Dist	COUNTY	ROUTE	POST MILES TOTAL PROJECT	SHEET No.	TOTAL SHEETS
08	Riv	215	R17.8/R19.2	257	475
 LICENSED LANDSCAPE ARCHITECT					
04-15-2014 PLANS APPROVAL DATE					
<small>THE STATE OF CALIFORNIA OR ITS OFFICERS OR AGENTS SHALL NOT BE RESPONSIBLE FOR THE ACCURACY OR COMPLETENESS OF SCANNED COPIES OF THIS PLAN SHEET.</small>					
URS CORPORATION 2020 EAST FIRST STREET, SUITE 400 SANTA ANA, CA 92705			RIVERSIDE COUNTY TRANSPORTATION DEPARTMENT 4080 LEMON STREET 8th FLOOR RIVERSIDE, CA 92502

ATTACHMENT "C" TO ADDENDUM NO. 1, PAGE 89 OF 115

<b>CONTRACTOR QUESTIONS AND RESPONSES</b>		
<b>1</b>	Question	Refer to Bid Item 129, Structure Concrete Retaining Wall, Bid Quantity = 1,731 cubic yards. Plan Sheet 253 of 475 shows 1,550 cubic yards and Plan Sheet 404 of 475 shows an additional 308 cubic yards. This totals 1,858 cubic yards. These quantities do not match the bid proposal. Please verify.

**IRRIGATION PLAN**  
SCALE 1" = 50' **IP-3**

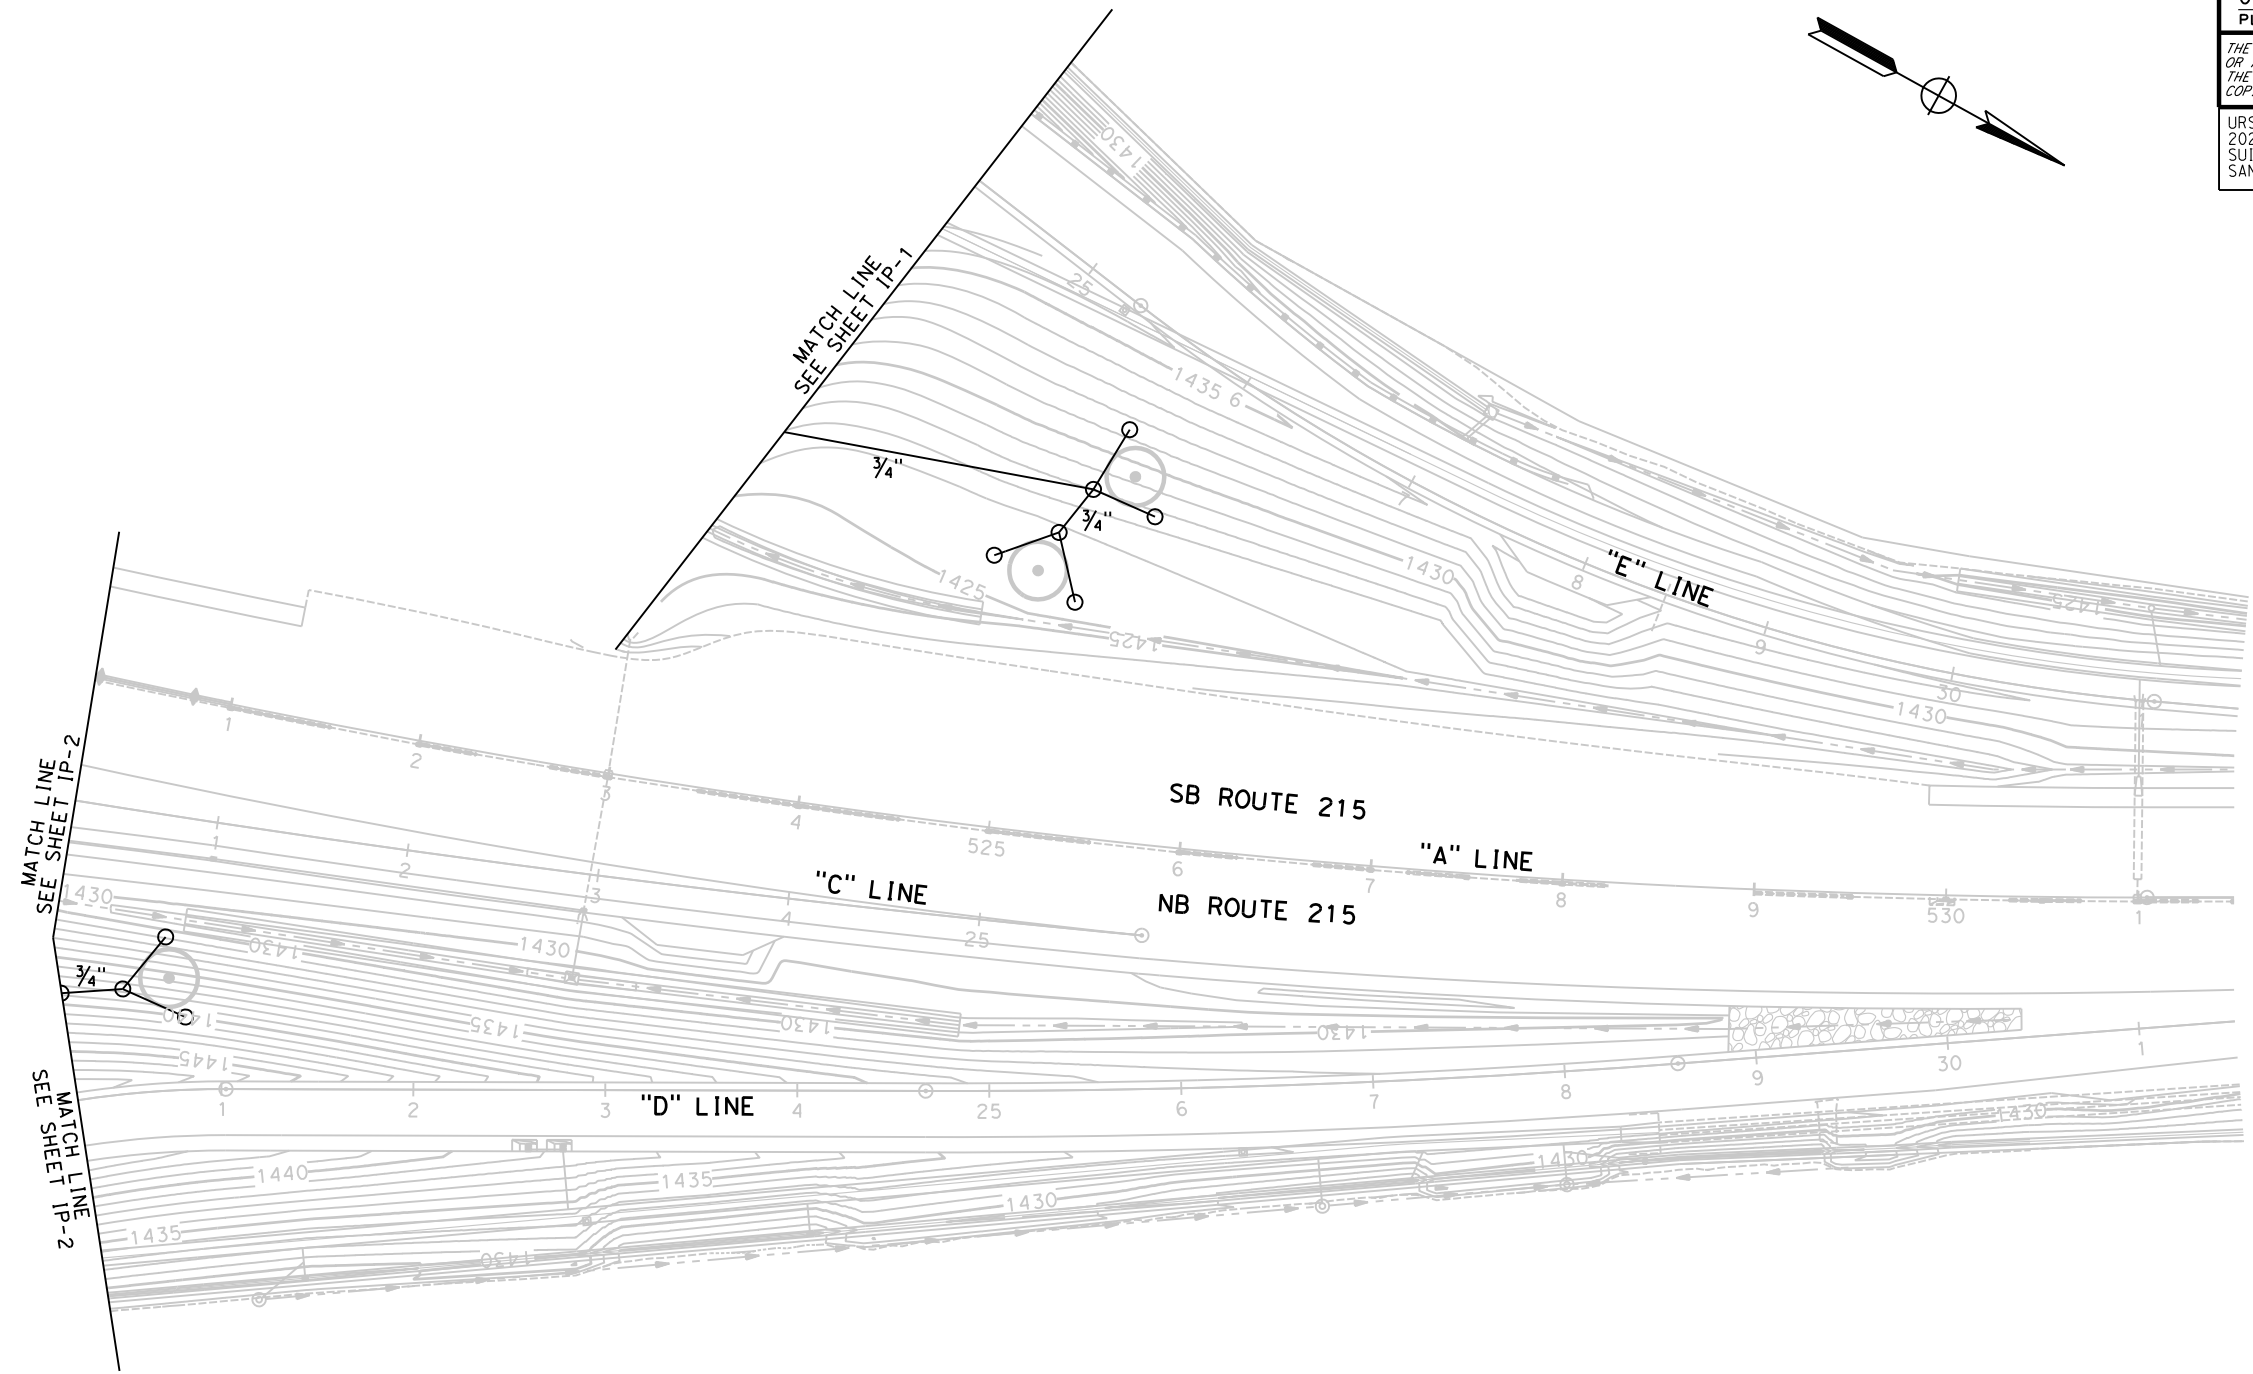
**1** REVISED PER ADDENDUM NO. 1 DATED NOVEMBER 12, 2014

**PLANTING PLAN**  
SCALE 1" = 50' **PP-2**

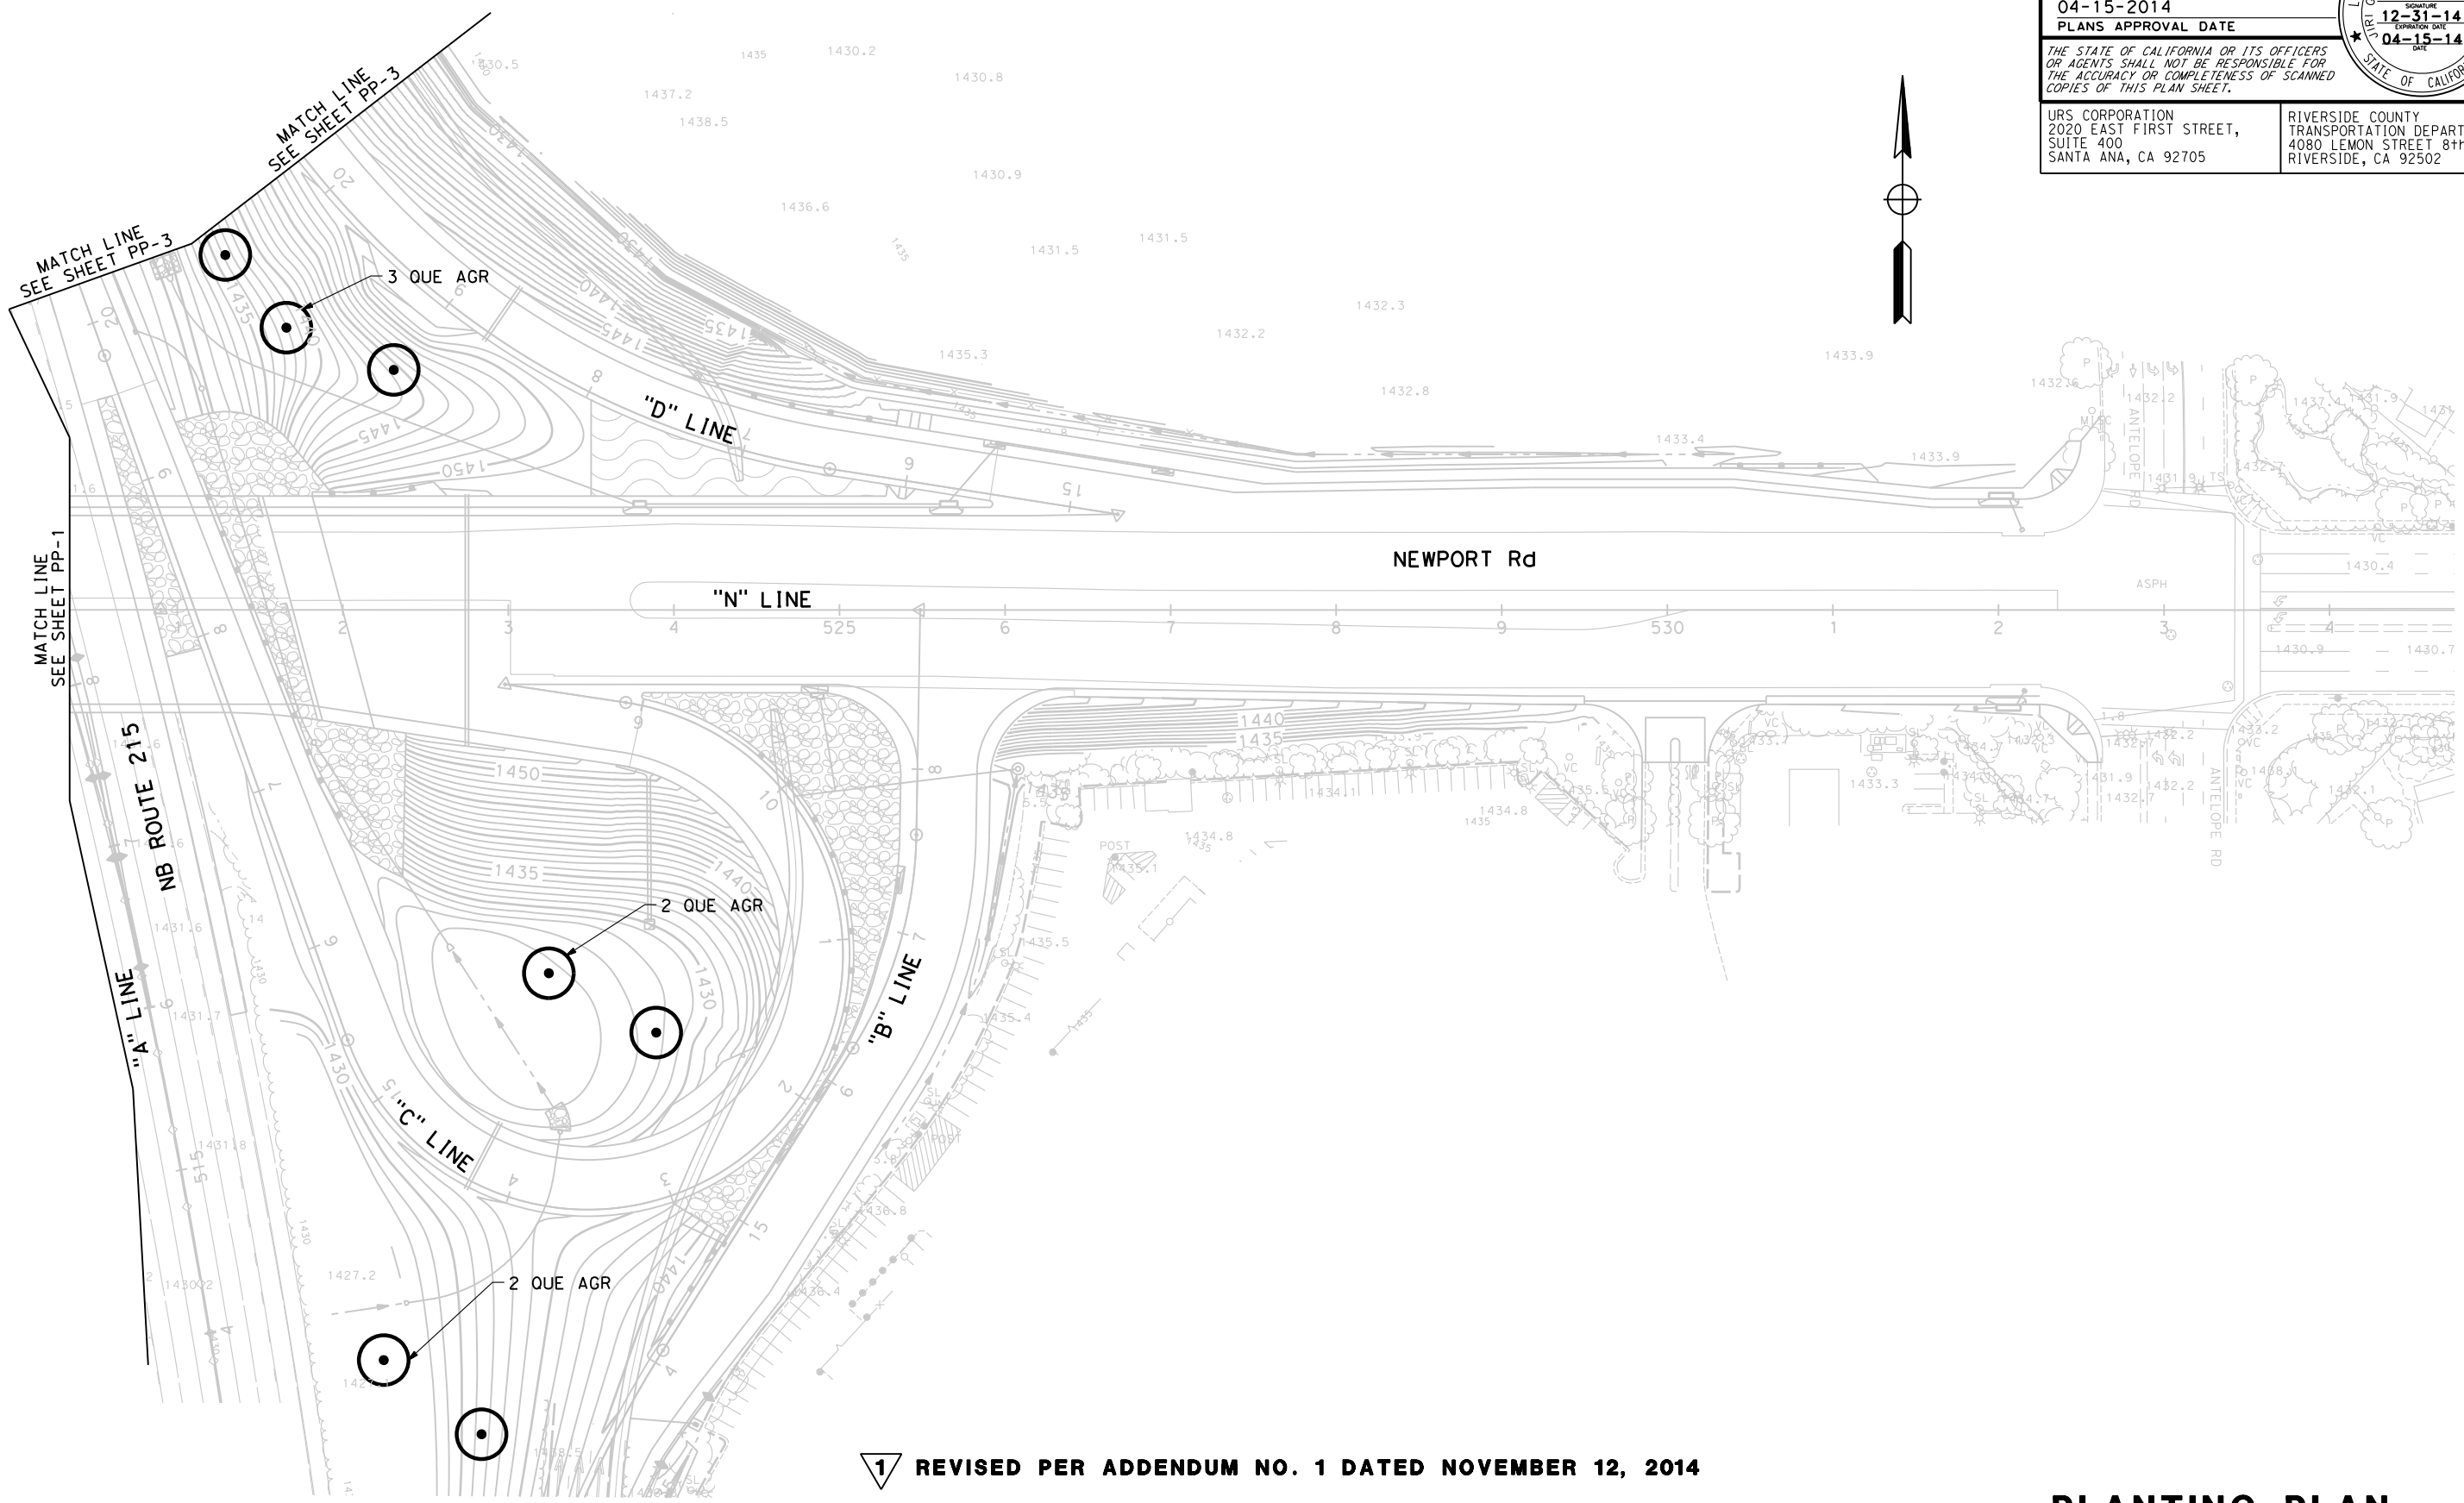
1 REVISED PER ADDENDUM NO. 1 DATED NOVEMBER 12, 2014

SCALE 1" = 50' E-7

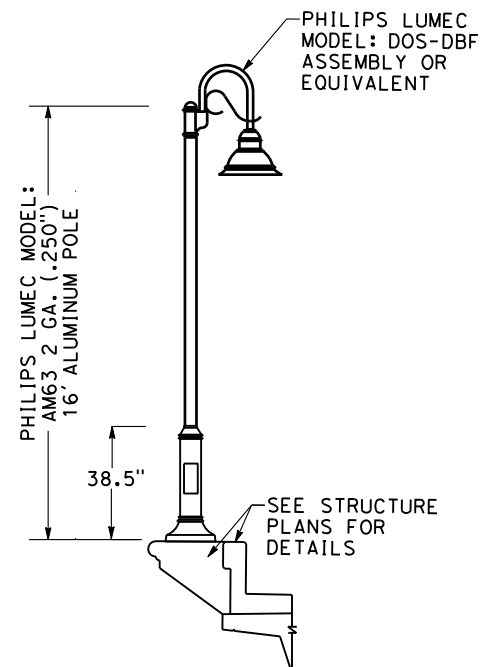
1 REVISED PER ADDENDUM NO. 1 DATED NOVEMBER 12, 2014

**STRUCTURAL SECTIONS:**

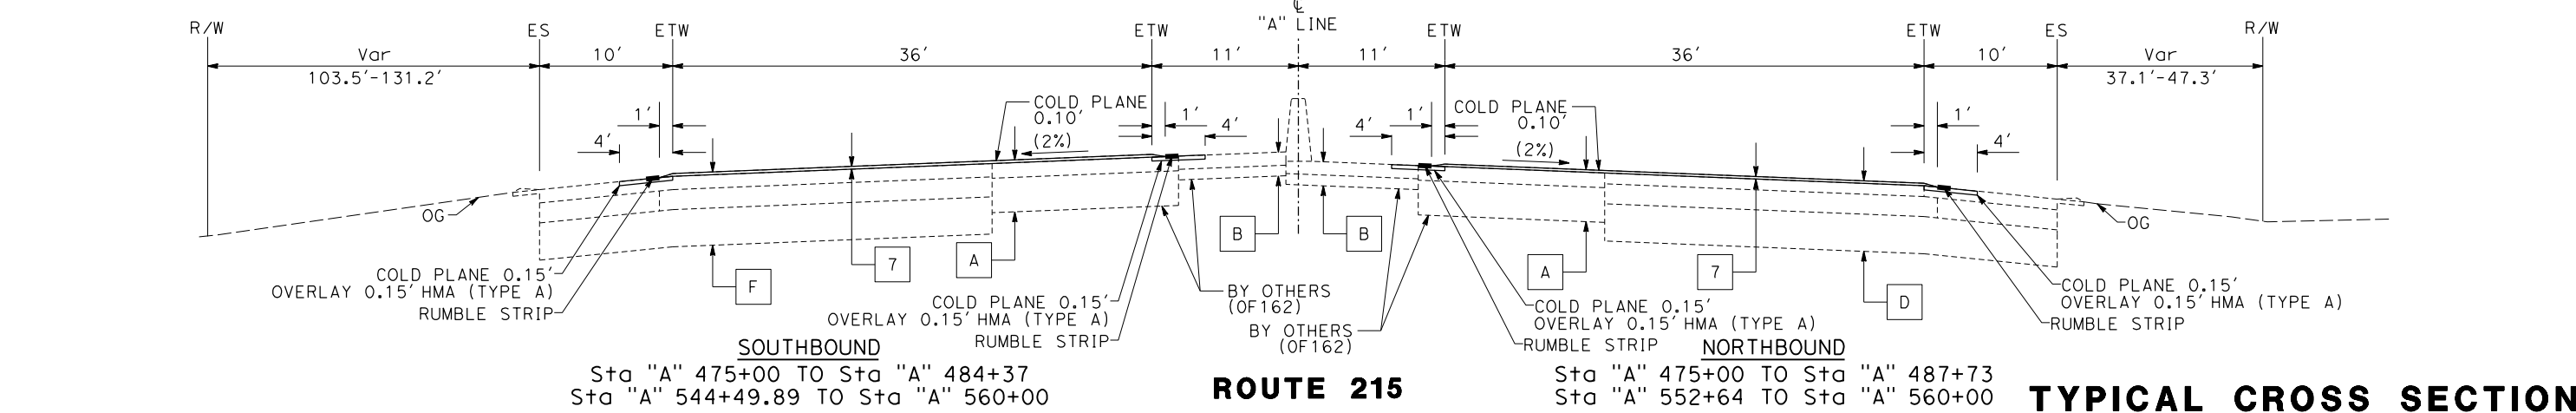
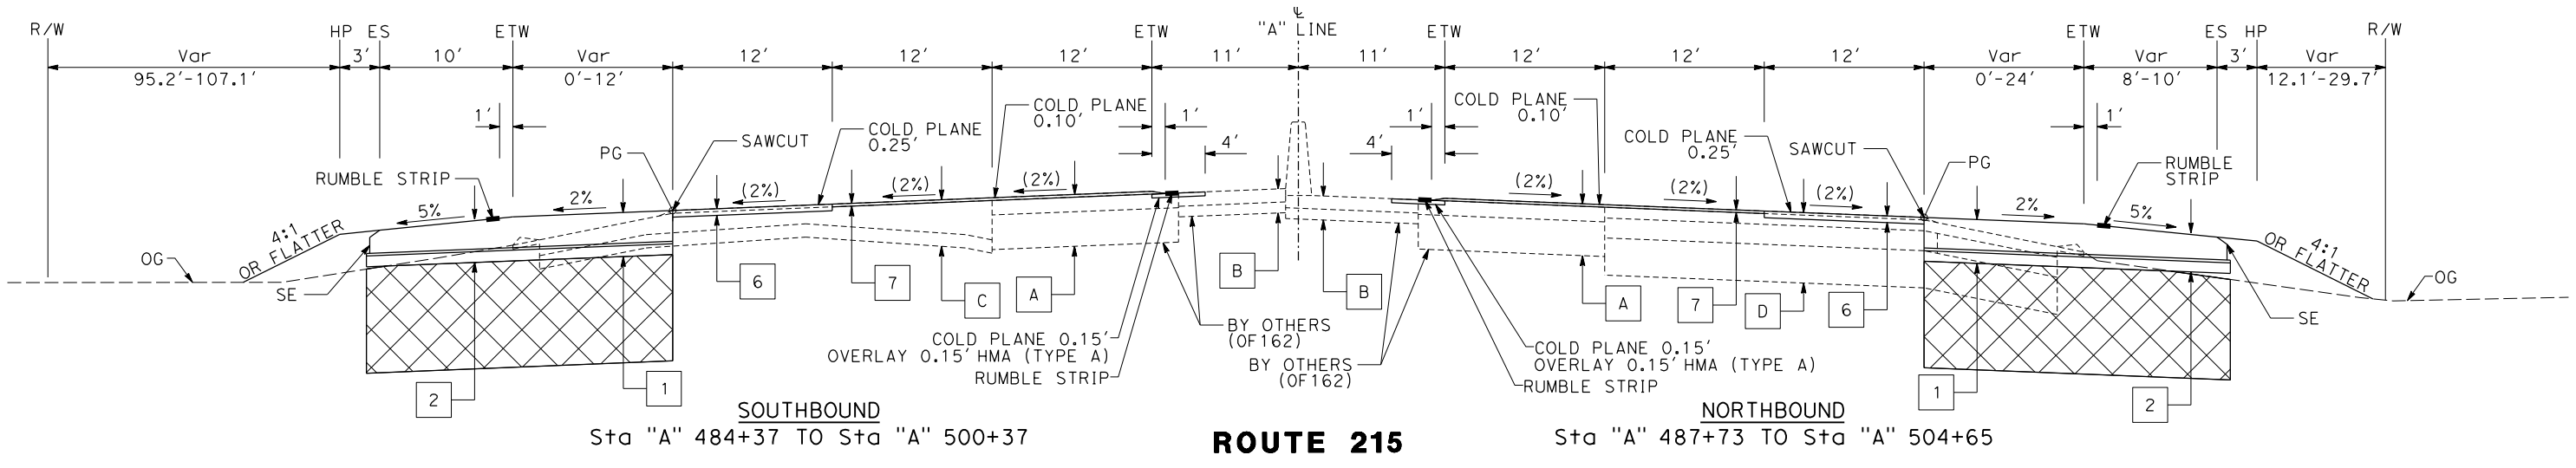
Response	<a href="#">The Temporary HMA Overlay is full depth HMA.</a>
<b>32</b>	Question	The Existing Structural Sections on Sheet X-1, and available typical cross sections do not specify which sections the existing ramps are composed or. Please indicate which structural sections can be used for ramp removals.

Response	<a href="#">Based upon record drawing data, the existing ramps consist of 0.50' Asphalt Concrete, 0.80' Aggregate Base and 1.25' Aggregate Subbase.</a>
<b>33</b>	Question	Sheet X-1 shows proposed structural sections 1-9. All structural sections except for 9 have been found on the plans. Please indicate where on the plans this structural section can be found.
